**73 Plender Street (former Parrs Head Public House), London NW1 0LB**

*Application for minor (non-material) amendment to existing planning consent 2012/0989/P.*

## Duty Planning Meeting

### Site: 73 Plender Street (former Parrs Head Public House)

Revised Bayham Place elevation, showing actual parapet (made good in parts) and reduced setback

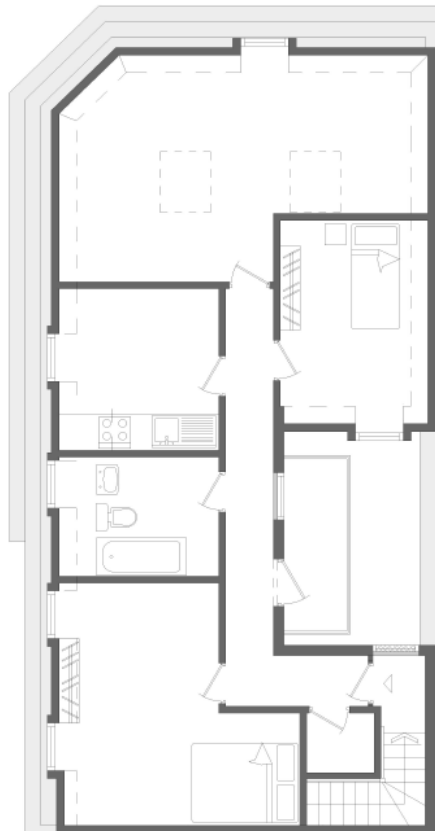
The approved plans included the addition of a mansard roof, set back by around 0.75 m from the parapet wall to minimize views to it from street level.

Unfortunately, it appears that the original applicant made a mistake when it came to the elevation drawings. On these drawings, it appears that the height of the parapet wall was underestimated. In reality, the parapet wall is in most places at least 0.5m higher than shown on previous drawings, hence obscuring most of the proposed mansard roof.

As a result of these discrepancies, we would like to reduce the setback from 0.75 m to around 0.2 m as shown on the following drawings. We will also need to slightly lift the dormer windows in order to allow enough light to penetrate into the flat.

Bayham Place elevation: Option 2 (preferable outcome)

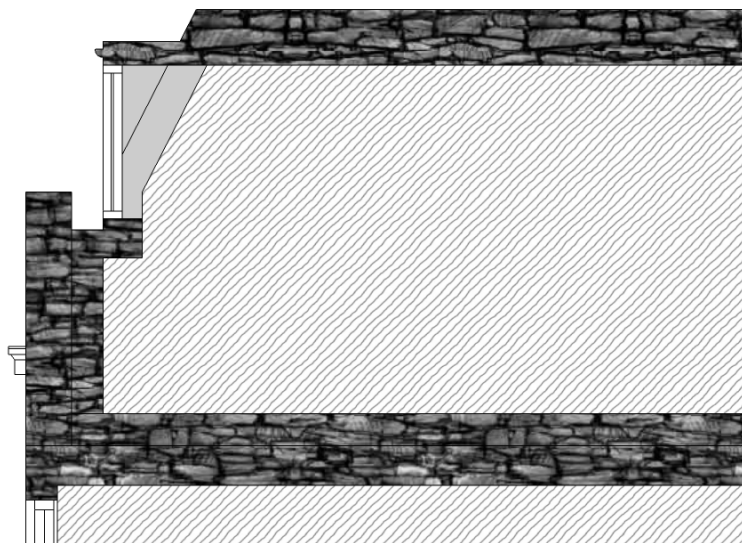
On the Plender Street elevation, we propose two centrally-placed window openings instead of only one. We believe this would better suit the form of the building whilst ensuring that these new openings are subordinate to the existing building.

On the Bayham Place elevation, we propose either one or two extra window openings to be vertically aligned with the existing blanked out windows of the existing building. The first option consistently aligns each 2<sup>nd</sup> floor window with a top-floor window opening subordinate in size. Due to the internal layout of the top-floor flat one of these new windows would need to be blanked out; however this would not be noticeable from the public realm. The second option bypasses this restriction but placing a singly window centrally-aligned above the two blanked out windows below.

This results in even gaps between each top-floor window opening and is in our opinion the preferable option.

- Is the LPA in principle satisfied with these proposals?
- Does the LPA agree that option 2 (one extra window facing on Bayham Place) is the preferable option?
- Given that these additional openings are proposed on street-facing elevations that already contain plenty of window opening, does the LPA recommend applying for these revision as minor, non-material amendments or will they recommend a full planning application? In the latter case, is the Council in principle satisfied with the preferred option?

In my view there is unlikely to be any issues with adding a second dormer window to the Plender Street side.

Revised top-floor dormer window section with actual parapet wall and reduced setback

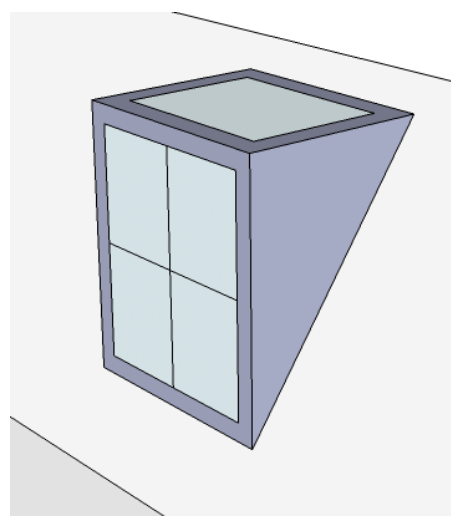
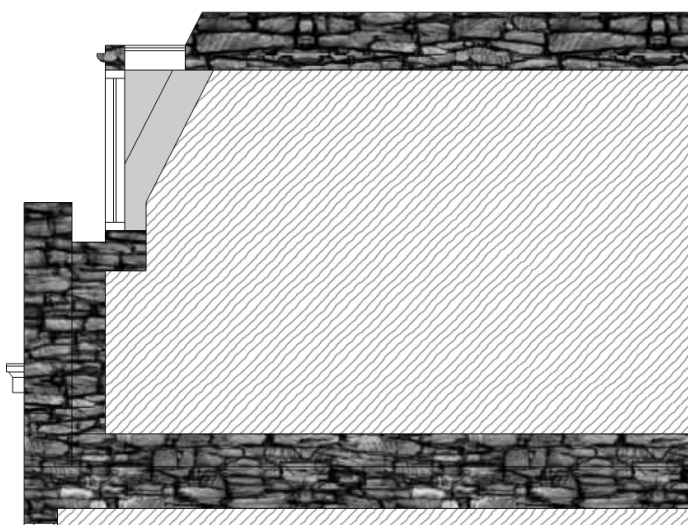
The existing proposal makes provision for dormer window openings on the top floor. In order to increase daylight levels, we propose to either a) make use of dormer openings with glazed roof element or b) provide sloped Velux/Conservation windows instead of vertical dormer windows. In the latter case, the parapet wall would hide most of the windows when seen from the pavement below or opposite the principal elevations.

- Would dormer windows with a glazed roof element be acceptable in principle as a minor non-material amendment as the glazed roof element cannot be seen from the public realm?
- Given that they would only be noticeable from afar, would the LPA accept sloped (eg. middle-hung) Velux/Conservation windows?

- 3.3 The proposed setback was also discussed at the duty planning meeting on 31 July 2012 with Amy Spurdle, who reconfirmed that an application for minor, non-material amendment is the most suitable way forward. In addition, no issues were foreseen with the proposed glazed roof element of the dormer windows or the internal rearrangements (including the addition of a clearly labelled study room).

Proposed top-floor flat layout alterations after reduced roof slope setback.

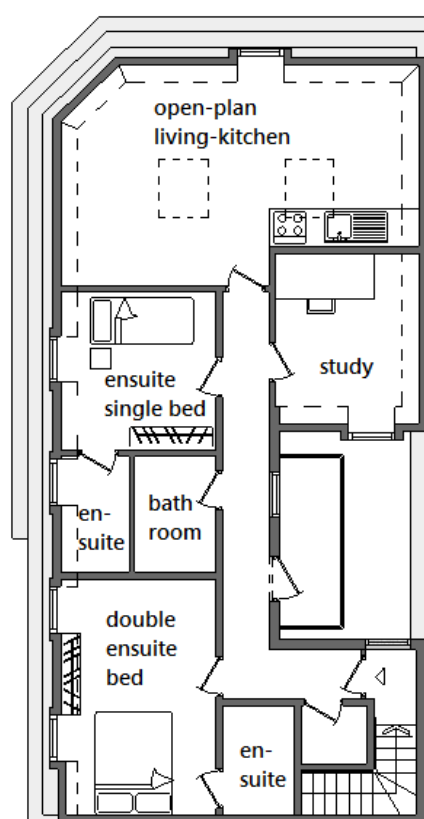
The reduced roof slope setback will increase the floor area of the top-floor flat by at almost 10m<sup>2</sup> and thus greatly benefit future occupiers. As a result, a few internal rearrangements are proposed, including making both bedrooms en-suite, making the living room/kitchen open-plan (with the kitchen element in the darker corner of the room) and adding a small study (in the room receiving less light).

Is the LPA in principle satisfied with the internal alterations, including the addition of a study room?  
Is there a risk of this room being considered large enough to be an additional bedroom?

Provided that the two bedrooms meet our residential development standards I cannot foresee any issues with creating a study, provided that you clearly label the room as a study on the plans and advertise the unit correctly.
